Access Compliance Report Public Rights-of-Way (Curb Ramps)

Main Street: N_DAISSY_ST Cross Street: AVENDALE_BLVD Location: NE

ADA ID: RPRK211111171233 Ramp Type: Type 4 - Parallel Initial Pass/Fail: Fail Overall Compliance: No Severity Score: 16

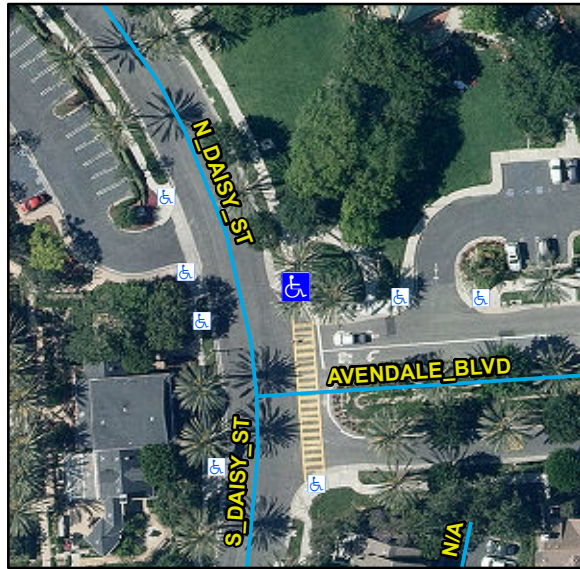
R204.3, R304.3.2, R304.5.3, STD 1115

Compliance	Description	Data	Compliance	Description	Data
N/A	Ramp Length LT (in)	132	N/A	Ramp Length RT (in)	136
Yes	Ramp Width LT (in)	89	Yes	Ramp Width RT (in)	89
No	Ramp Run Slope LT (%)	9	Yes	Ramp Run Slope RT (%)	1.7
No	Ramp Cross Slope LT (%)	2.6	No	Ramp Cross Slope RT (%)	3.2
N/A	Landing Present	N/A	N/A	DWS Provided	N/A
N/A	Landing Length (in)	N/A	N/A	DWS Contrast	N/A
N/A	Landing Width (in)	N/A	N/A	DWS Length (in)	N/A
N/A	Landing Run Slope (%)	N/A	N/A	DWS Full Width	N/A
N/A	Landing Cross Slope (%)	N/A		DWS Offset Type	N/A
N/A	Landing Movement Obstructed?	N/A	N/A	DWS Offset Left (in)	N/A
	Landing Movement Type	N/A	N/A	DWS Offset Right (in)	N/A
N/A	Landing Shared	N/A			
N/A	Clear Space	Yes			
N/A	Clear Space To Crosswalk (in)	N/A			
N/A	Marked Crosswalk 1	No	N/A	Marked Crosswalk 2	Yes
	Crossing 1 Direction	W		Crossing 2 Direction	S
	Marked Crosswalk 1 Width (in)	N/A		Marked Crosswalk 2 Width (in)	144
N/A	Ramp Inside Crosswalk 1	N/A	N/A	Ramp Inside Crosswalk 2	Yes

Remove & Replace Curb Ramp With Two New Directional Ramps or Equivalent.
